Hardwick Development Review Board  
Conditional Use Review Request  
*Applicant: Caledonia County Natural Resources Conservation District*  
*Landowner: Bair, LLC*  
*64 North Main Street, Hardwick*  
*Application #2021-023*  
*June 2, 2021 via Zoom*

*To consider a Conditional Use Review request by Caledonia County Natural Resources Conservation District for installation of an underground municipal storm water treatment system in the Central Business and Village Neighborhood zoning districts. Development would occur at 64 North Main Street, Hardwick, VT. Site is in Zone AE in the Flood Hazard Area Overlay and the Floodway of the Lamoille River.*

**Subject:** North Main Street Stormwater Improvements – Hardwick, VT

Figure 1. FEMA Flood Insurance Rate Map

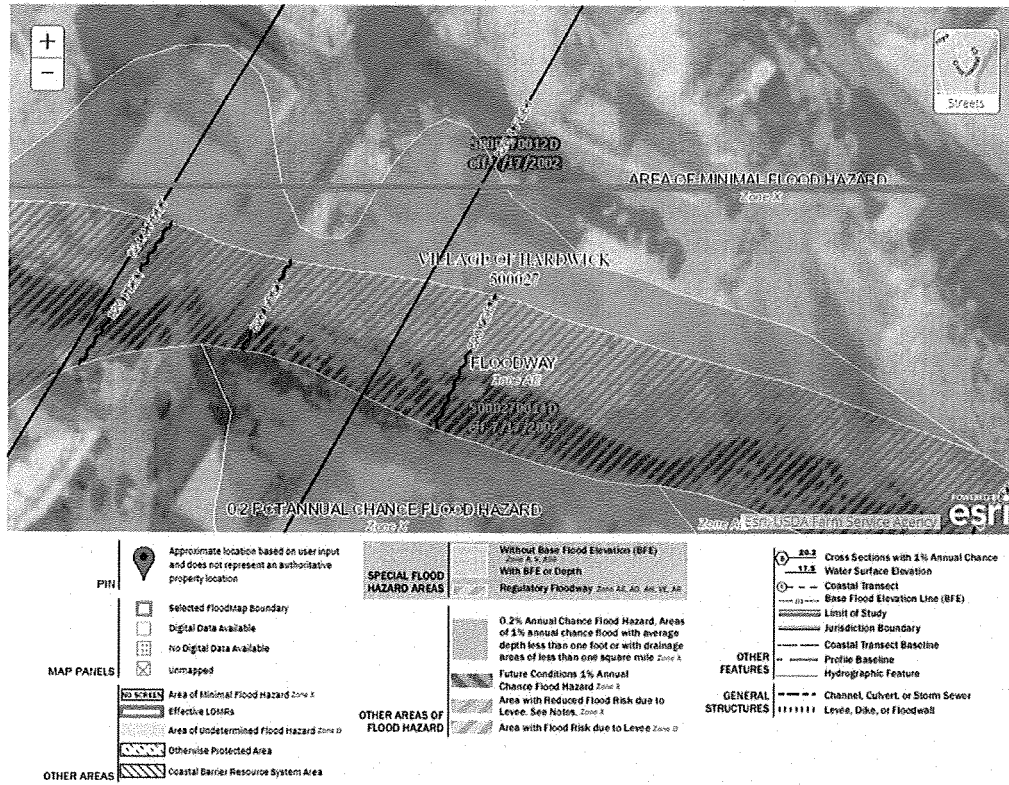
An existing stormwater discharge will be used as the main outflow from the proposed treatment system. In addition, two additional outlets will be installed to bypass runoff that exceeds the system's inflow capacity. The outfalls are in the FEMA effective 100-year flood elevation (Table 1 and Figure 1) and thus each of the three pipes will be fitted with backflow prevention valves to stop flood waters from entering the treatment system and site.
